TO: Mercedes-Benz Dealer Principals, General Managers, Sales Managers, Service Managers, Parts Managers	FROM: Gregory Gunther, Department Manager, Vehicle Compliance and Analysis, Engineering Services
RE: Emission Modification Notification – [[2020050028]] MY11-12 E350 BlueTec Update – Emission Modification Category (EMC) #8	DATE: April 7, 2022

Emission Modification Notification			April 7, 2022
Campaign No.:	EMC#	Campaign Desc. :	BlueTEC Update – MY11-12 E (W212)
2020050028	8	19P4992019	
This is to notify you of an Emission Modification Notification to update the emission control system on approximately 5700 Model Year (“MY”) 2011-2012 E350 BlueTEC (W212) diesel vehicles. Emission Modification information will be visible on the https://BlueTecUpdate.mbusa.com website and may generate questions from Owners and Lessees. Affected VINs will be flagged in VMI as “OPEN” on April 7, 2022.			
Background			
Issue	Mercedes-Benz USA, LLC (“MBUSA”) is modifying the emission control system on certain diesel vehicles. The Emission Modification for MY 11-12 E350 BlueTEC (W212) vehicles has been approved by EPA and CARB, and is now ready for installation. An authorized Mercedes-Benz Dealer will i

Figure 1

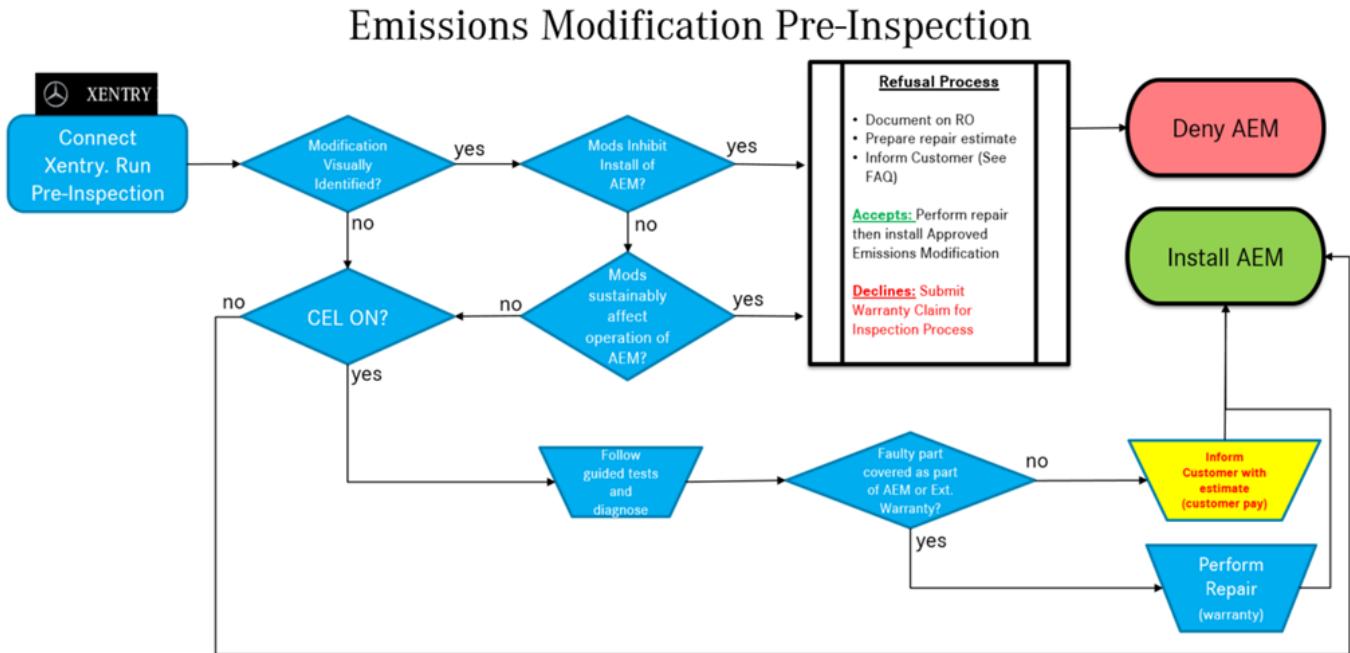
1.4 Pre-Inspection Overview (Figure 1)

Figure 6

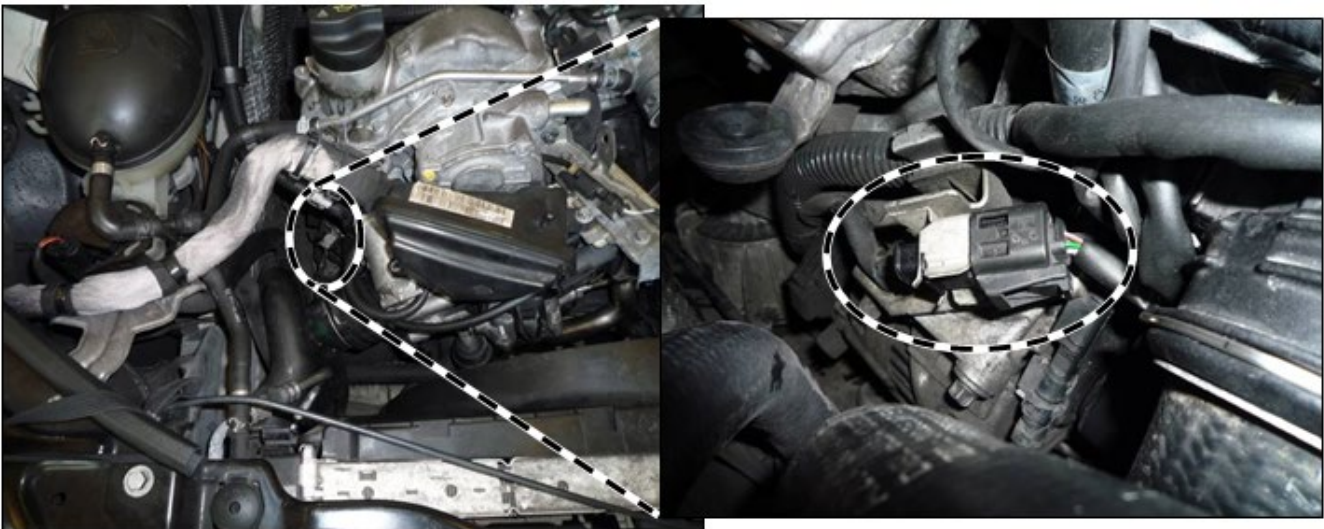
8. Install the plug housing (A 000 545 40 39) on the electrical connection for the O2 sensor (Figure 6).

i The electrical connection of the O2 sensor is **no longer** needed!
